FAX
TRANSMITTAL

To: Mr. Bhachu
U.S. Nuclear Regulatory Commission
Date: 2/7/02 No. pages 13
Fax 301 415 5369

This fax and the attachments within address the issues your office has regarding the Met One Instruments registration request for the model E-BAM beta attenuation mass monitor.

| DECIMAL | | E-BAM | | O-RING, 2-013 | | |

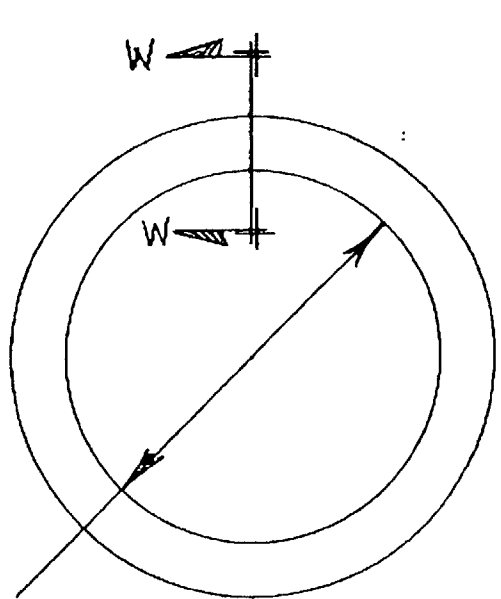
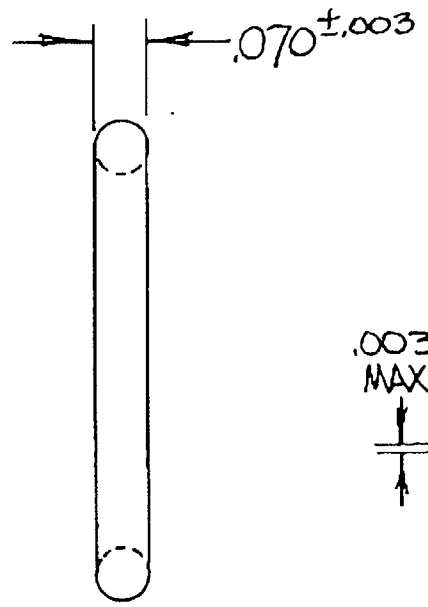
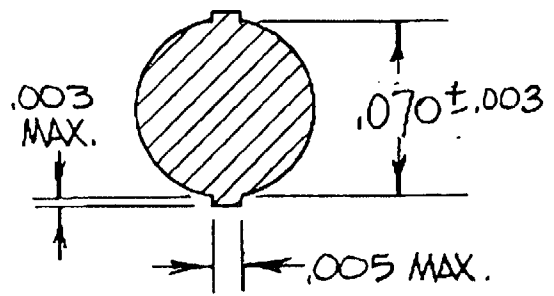
Issue #2:

The drawing for the O-Ring, Part# 720202 has been added to the Appendix A (Detailed Drawings) of the application. The O-Ring drawing calls out the material and characteristics of the O-Ring. Furthermore, page 2 of the Assembly procedure in Appendix C of the application has been modified to include step 3 and 4. These steps prevents over tightening and hold the source securely in place.

- 1.) MATERIAL - NITRILE (BUNA N)
DUROMETER 70 ± 5 SHORE A
- 2.) MFR/PN - PARKER 2-013-N674-70
(SIZE PER AS568A-013)

| ANGULAR ± 1/2° | | | | | TITLE: SOURCE/DETECTOR ASSEMBLY E-BAM | | | | |

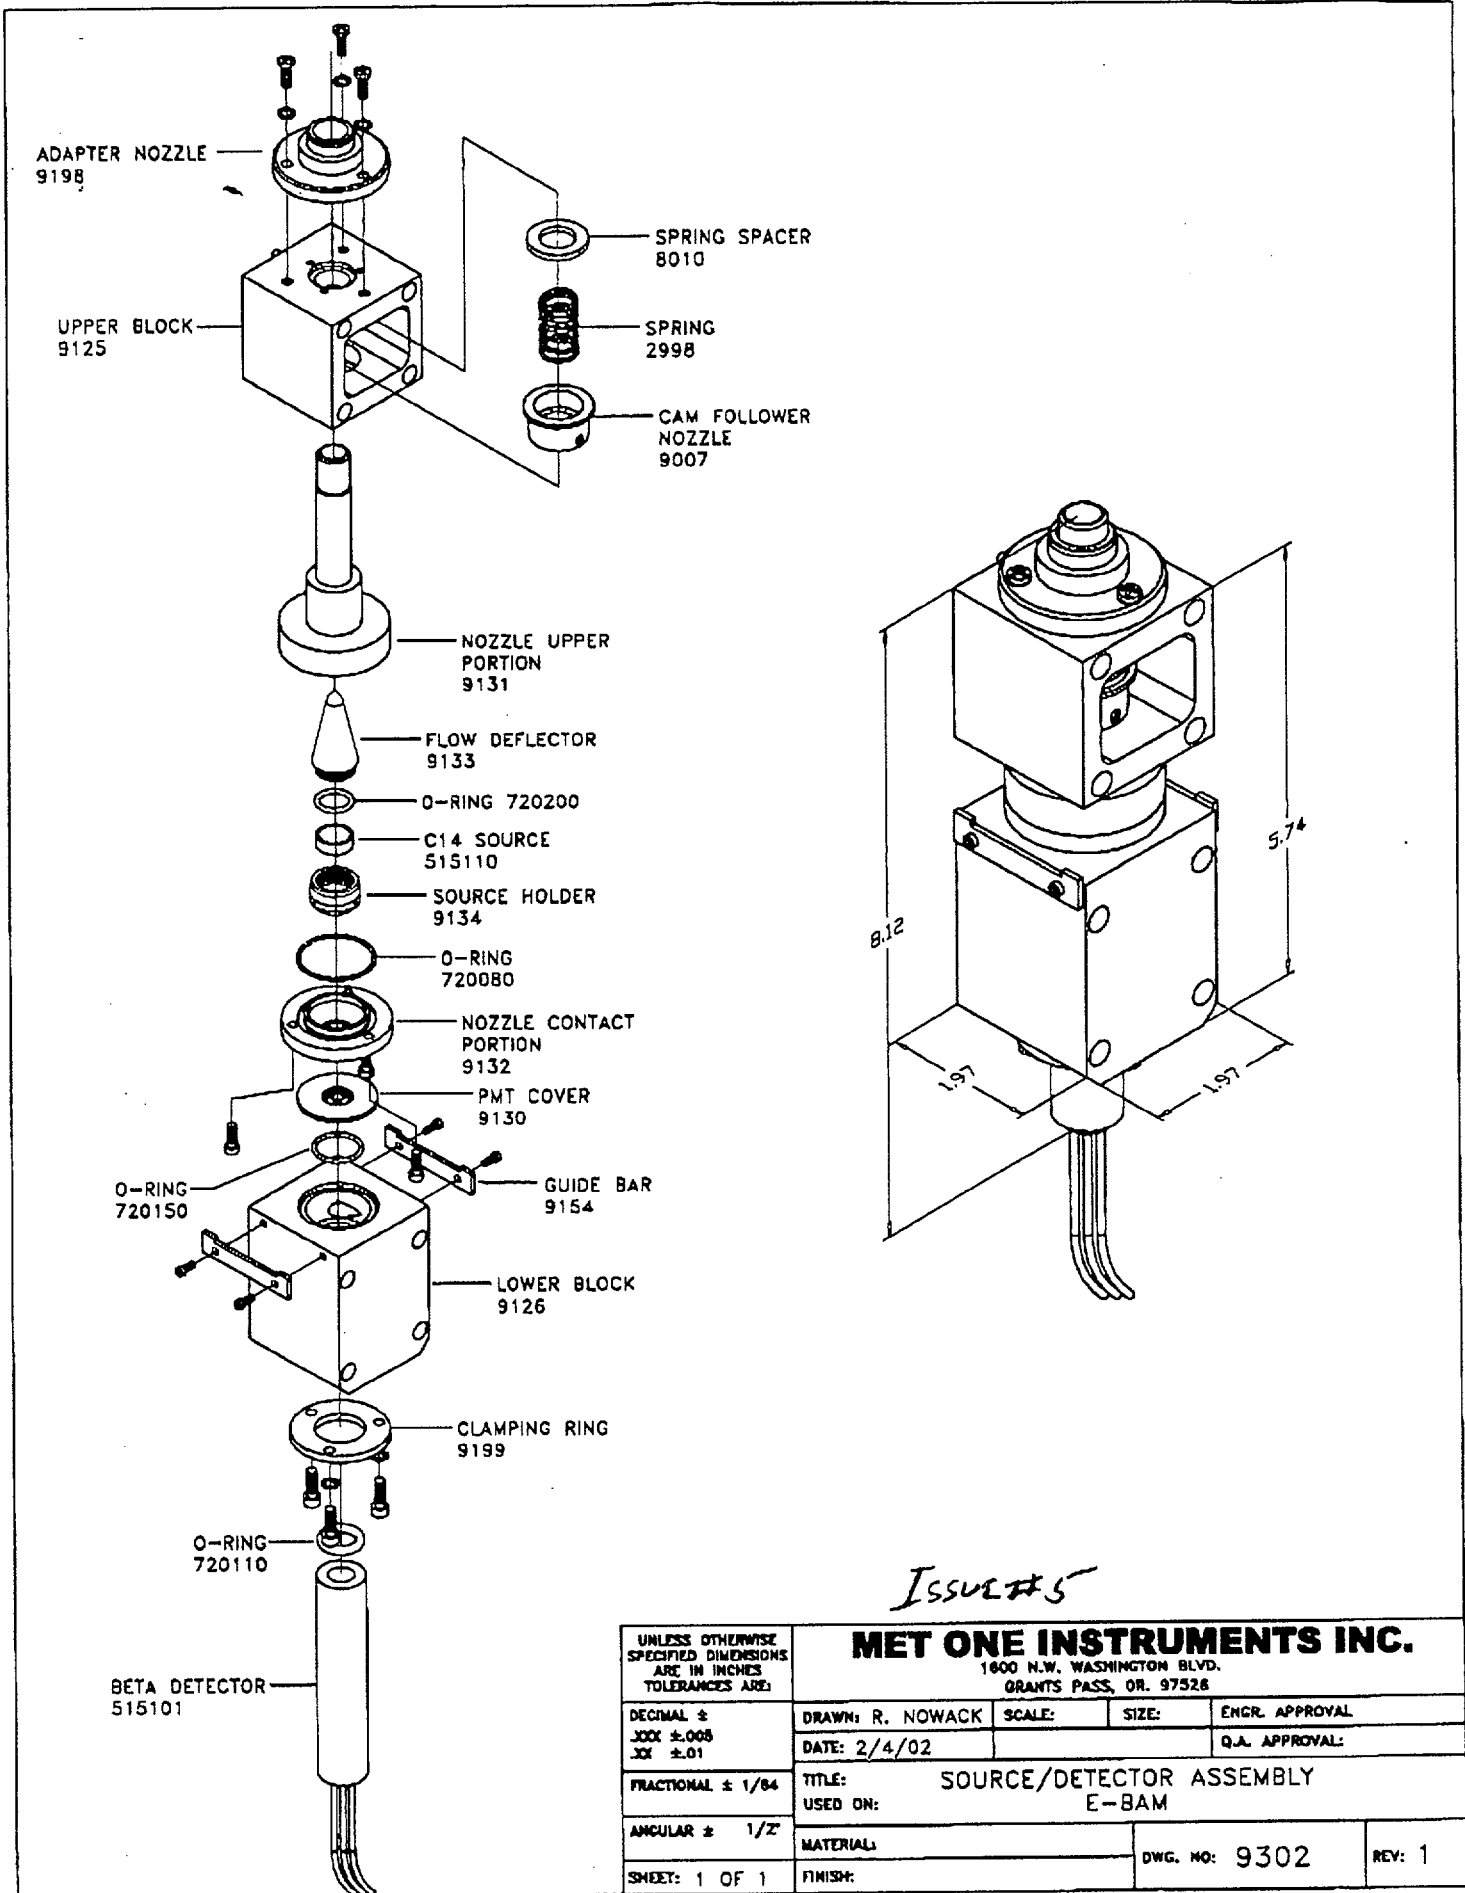
Issue #5:

An assembly drawing of the important containment parts has been added to Appendix A (Detailed Drawings) of the application. Overall dimensions are included.

ISSUE #5

ISSUE #9

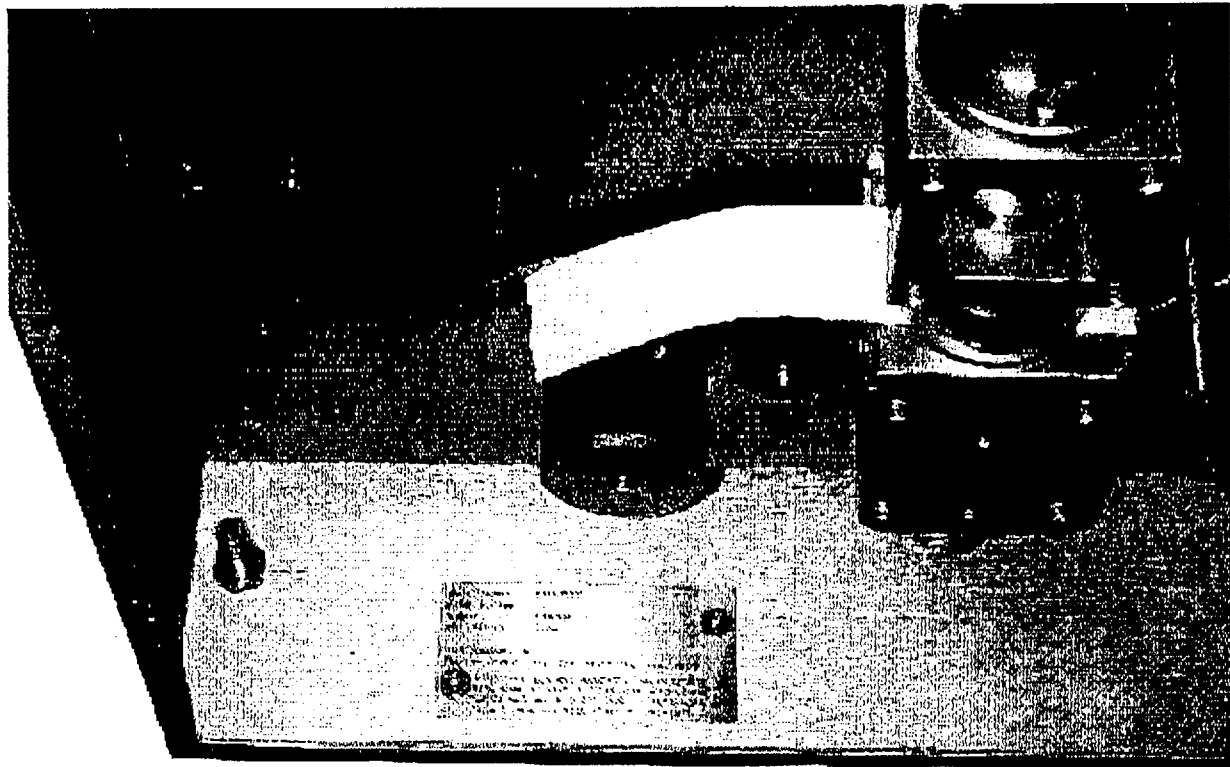
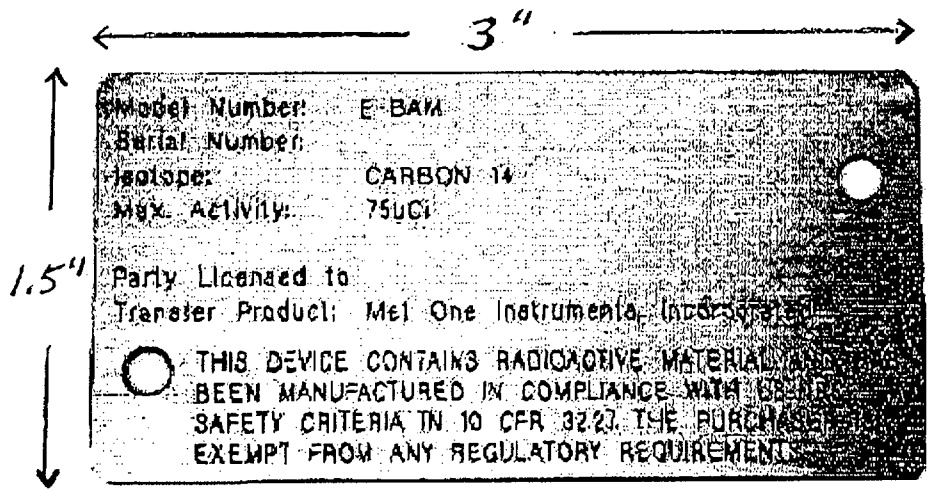
Issue #9:

The label dimensions have been added to the drawing in Appendix D of the application.

The label is an etched stainless steel plate and it is attached to the E-BAM transport with two rivets
